有關的規劃申請編號 The application no. to which the comment relates Y/1-DB/2

Area 6f, Lot 385 RP & Ext (Part) in D.D. 352, Discovery Bay

To rezone the application site from "Other Specified Uses" annotated
"Staff Quarters (5)" to "Residential (Group C) 12"
(Y/I-DB/2)

DISCOVERY BAY OPTIMIZATION OF LAND USE - AREA 6F

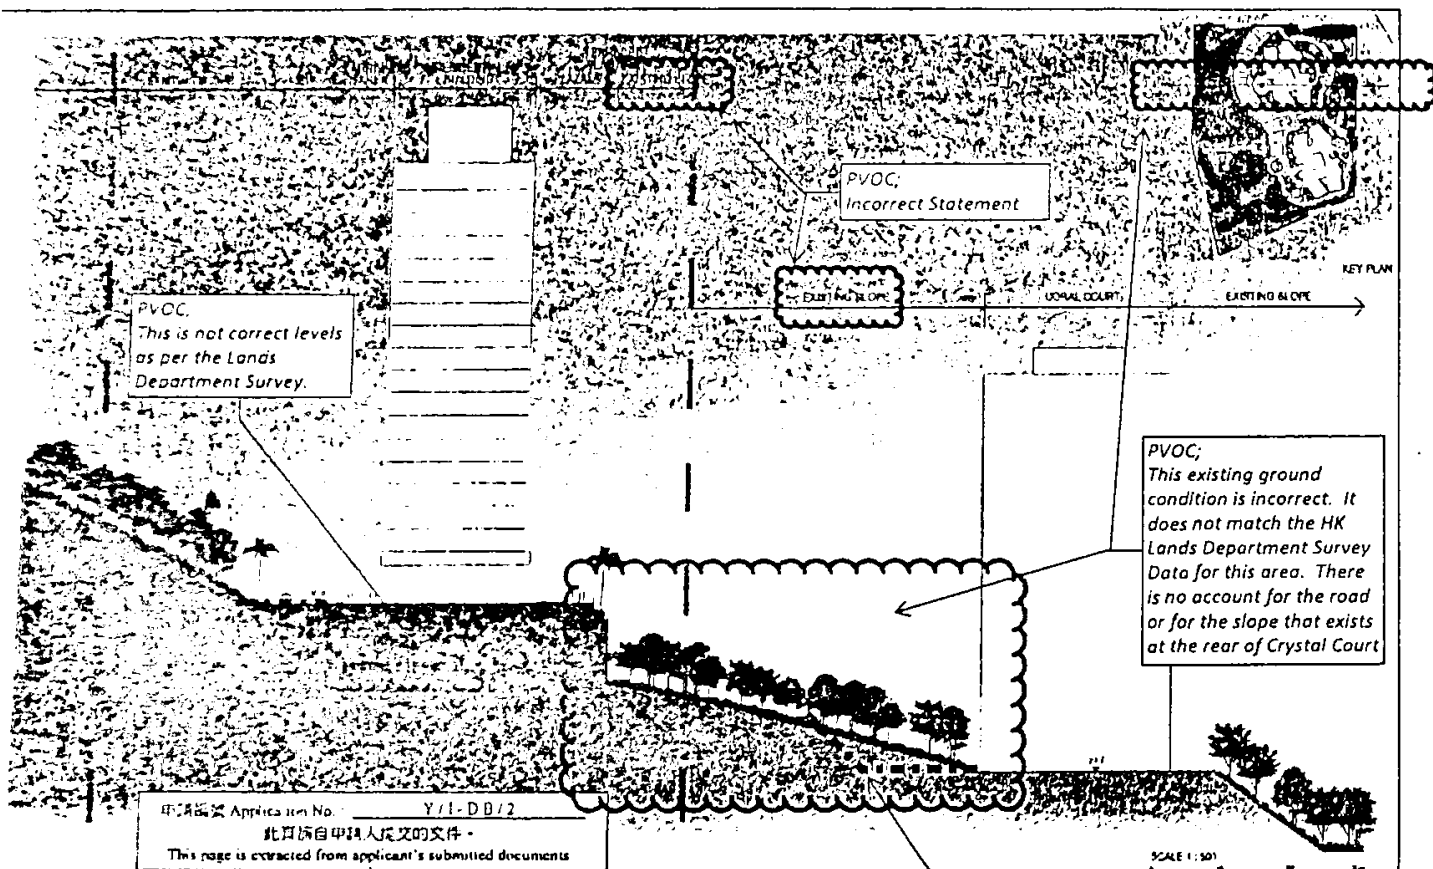
b. Optimisation of land use figure B.2. This figure includes incorrect statements about the existing slopes since the existing slope does not match the profile indicated by HKR's consultant: the existing slope profile shown in the figure does not reflect the correct levels as per the Lands Department Survey; the existing ground condition shown in the figure is incorrect since it does not match the Lands Department Survey data for this area. Furthermore, there is no account for the road or for the slope that exists at the rear of Crystal Court.

PVOC;
Existing does not match the profile
indicated by the consultant.

申請編號 Application No. : Y/1-DB/2

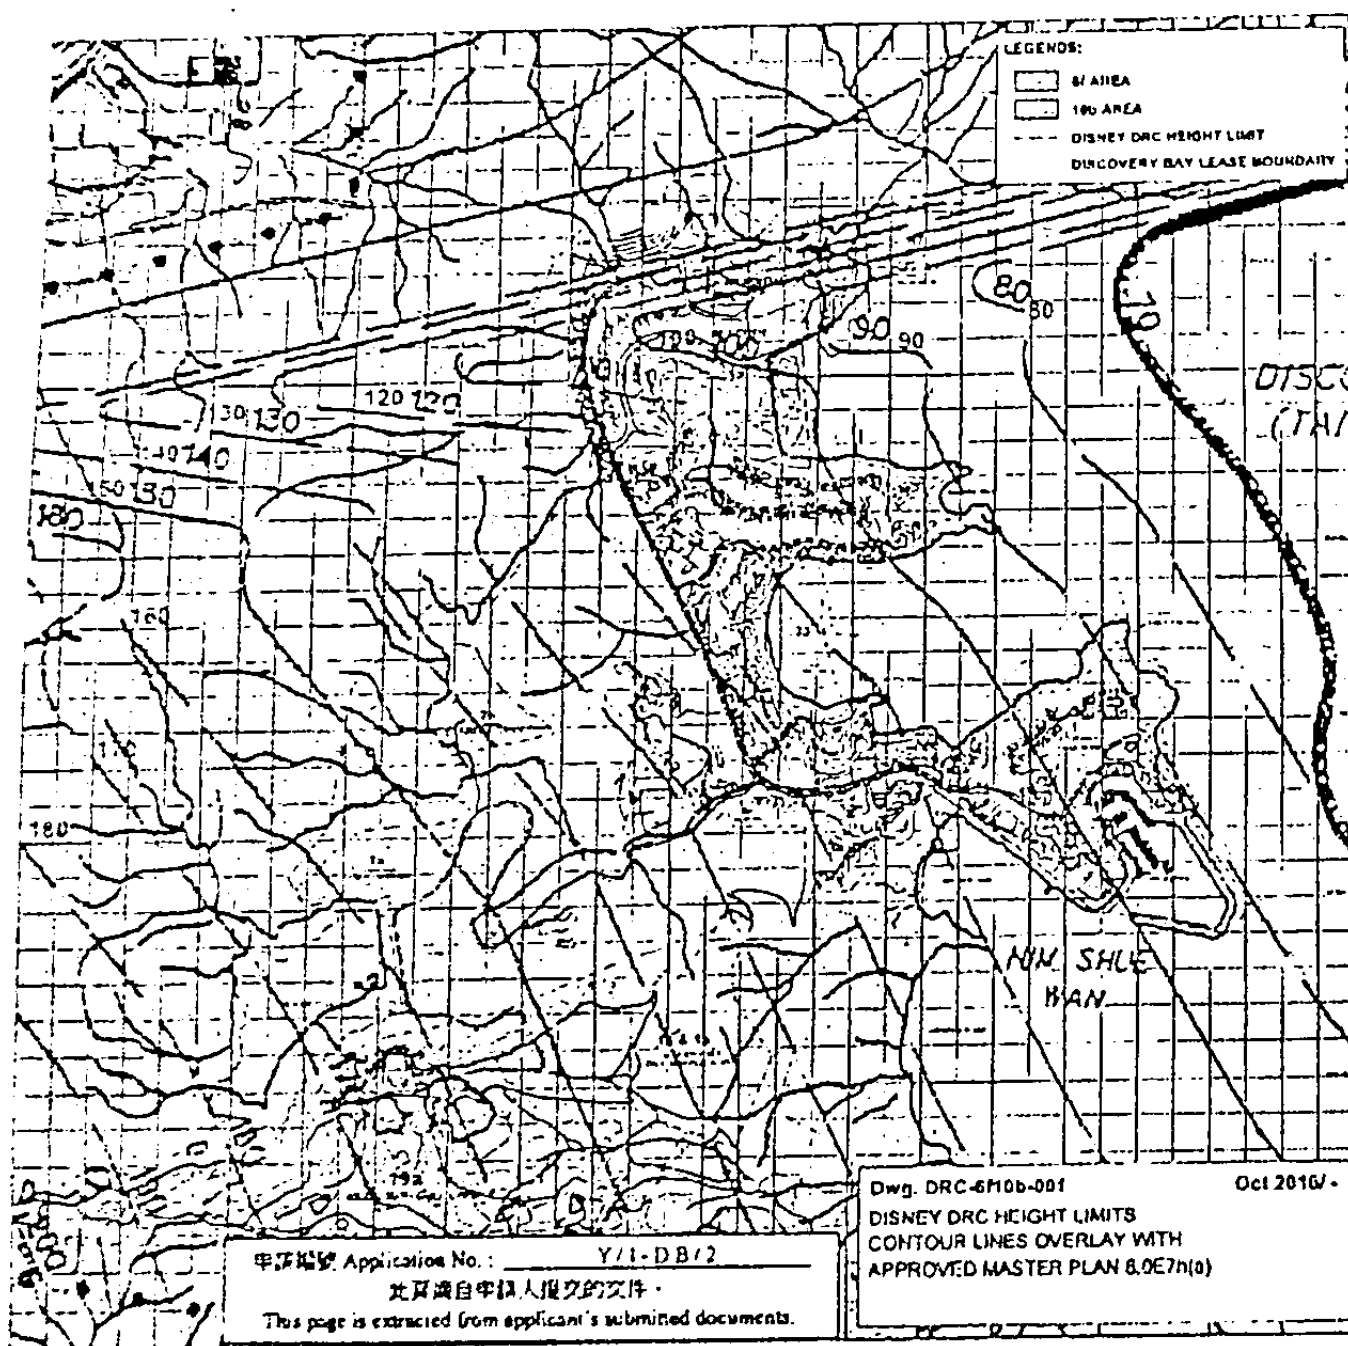
b. Figure B.9 view from DB Plaza – these poor quality photomontages hardly reflect the views from the Plaza on a clear day as illustrated in the VOC photos in Annex 1 to this submission.

PVOC;
*These poor quality
 Photo-montages hardly
 reflect the views from the
 Plaza on a clear day - see
 attached.*
